PRELIMINARY ASSESSMENT REPORT

PROJECT: New 230-27.6 kV Transformer Station

CAA ID No. 2000-030

Cambridge and North Dumfries Hydro Inc. New 230-27.6 kV Transformer Station

TABLE 1

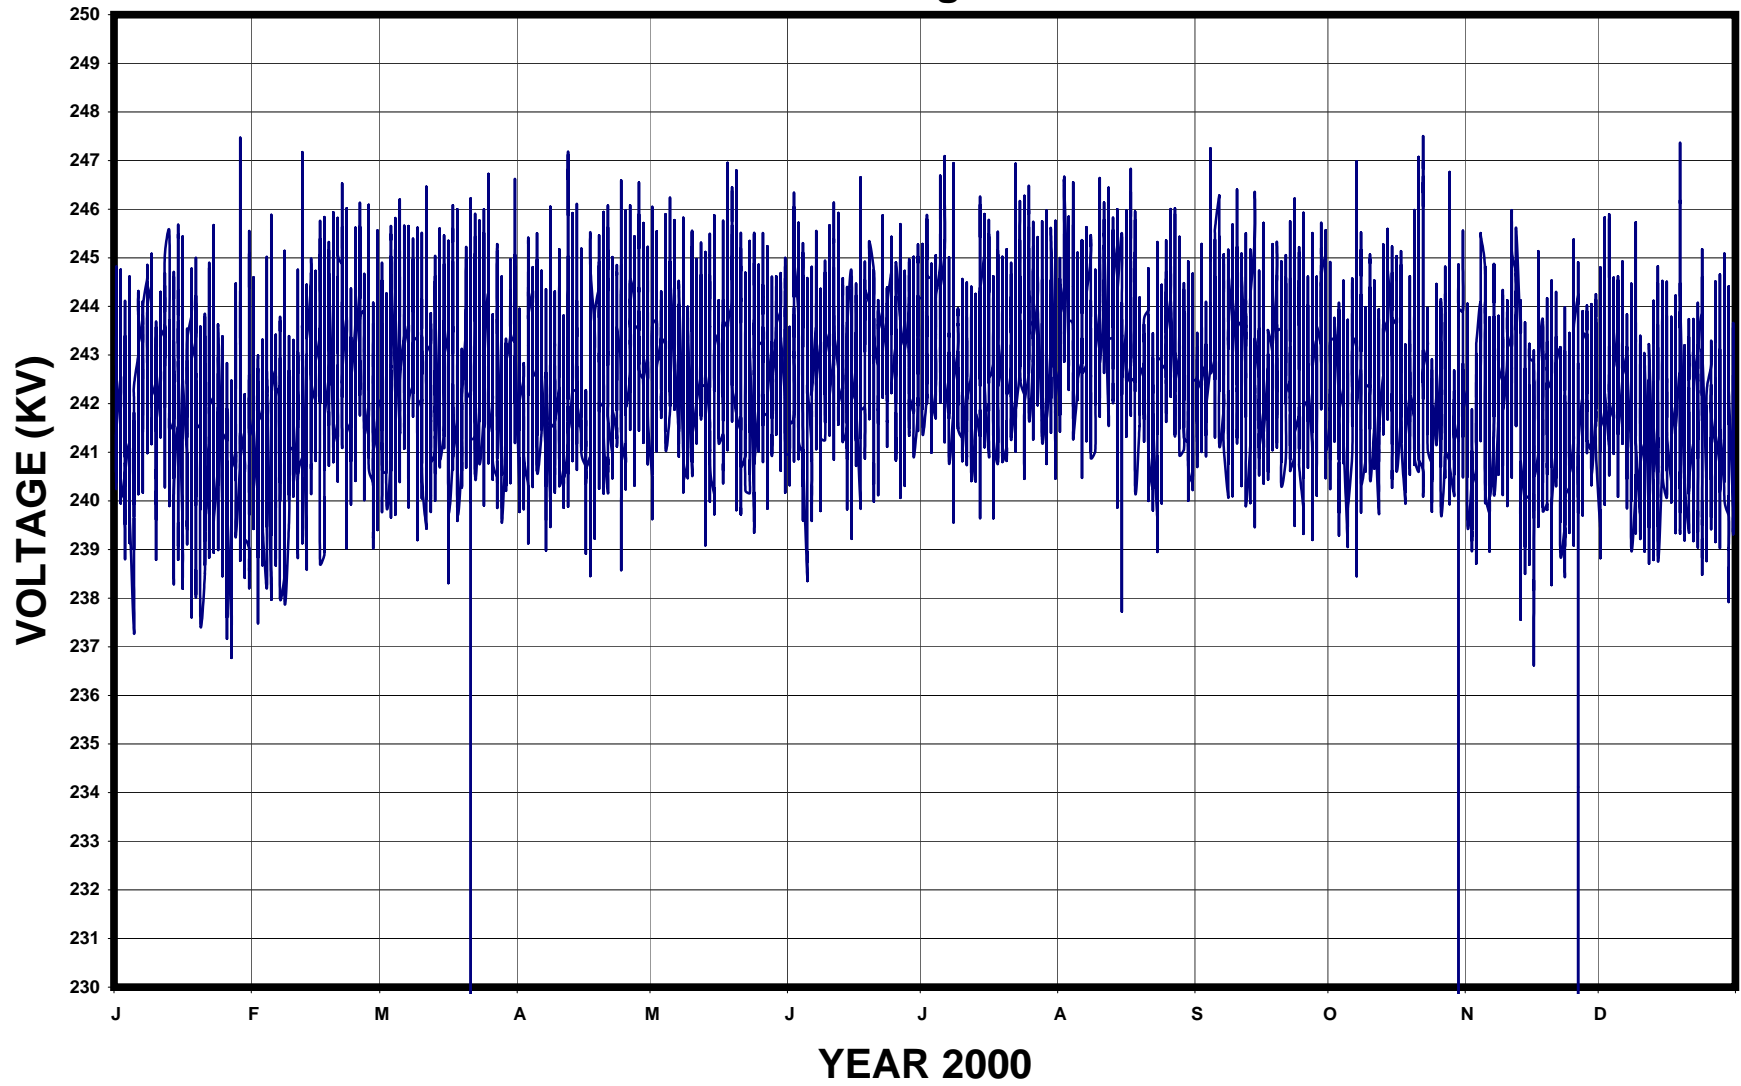
It is noted that with no corrective measures taken, circuit M21D, Galt Jct x Preston TS, will be overloaded in 2006, with M20D out of service.

MEASURES TAKEN	ADEQUATE UNTIL	DETAILS
(1) No Measures taken	2002	2002: Power factor < 0.9 2006: Loading M21D exceeds rating of 1120 A 2009: Loading M20D exceeds rating of 1120 A 2010 Ubrupt voltage change for line cont. > 10%
BASED ON ADEQUACY OF M21D WITH OUTAGE OF M20D

(2) Adding 1 x 20 MVAR, 27.6 kV capacitor at the new C/ND Hydro TS	2005	2006: Loading M21D exceeds rating of 1120 A
(3) Adding additional 1 x 20 MVAR, 27.6 kV banks at the new C/ND Hydro TS	2006	2007: Loading M21D exceeds rating of 1120 A

(4) Increasing the capacity of the Galt Jct x Galt section of M21D up the max operating temperature of 150°C (feasibility and cost to be determined by Hydro One) (Estimated rating = 1350A)	2009	2010: Loading M21D exceeds rating of 1350 A 2010 Ubrupt voltage change for line cont. > 10%

(5) (4) + (2)	2010	2011: Loading M21D exceeds rating of 1350 A
(6) Increasing the capacity of the Galt Jct x Galt TS section of M21D by reconductoring with 1192.5 ACSR conductor strung for 150°C (feasibility and cost to be determined by Hydro One) (Estimated rating = 1580A)	2009	2010: Ubrupt voltage change for line cont. > 10% 2013: Loading M21D exceeds rating of 1580 A

(7) (6) + (2)	2011	2012: Ubrupt voltage change for line cont. > 10%
BASED ON ADEQUACY OF M20D WITH OUTAGE OF M21D		
(5) Increasing the capacity of the Galt Jct x Galt TS section of M20D by increasing operating temperature to 150°C. (Assumes 1x20Mvar capacitor installed)	2011	2012: Ubrupt voltage change for line cont. > 10%

- Increase capacity of the Galt Jct x Preston Jct section of M21D by:
 - making modifications to allow operation at 150°C. This increases ampacity to approx 1350A and provides adequate capacity until about 2010 (or when total load on Galt/Preston/New TS/Courtice Steel reaches ~ 460 MVA) (Notes ii., iii.)
 - AND/OR
 - Reconductoring with larger/higher ampacity conductor. Assuming the use of 1192.5 kcmil ACSR conductor strung for 150°C operation , this will increase ampacity to approx 1580A and provides adequate capacity until 2014 (or when total load on Galt/Preston/New TS/Courtice Steel reaches ~ 522 MVA) (Notes ii., iii.)

- Increase capacity of the Galt Jct x Preston Jct section of M20D (Notes iii.).
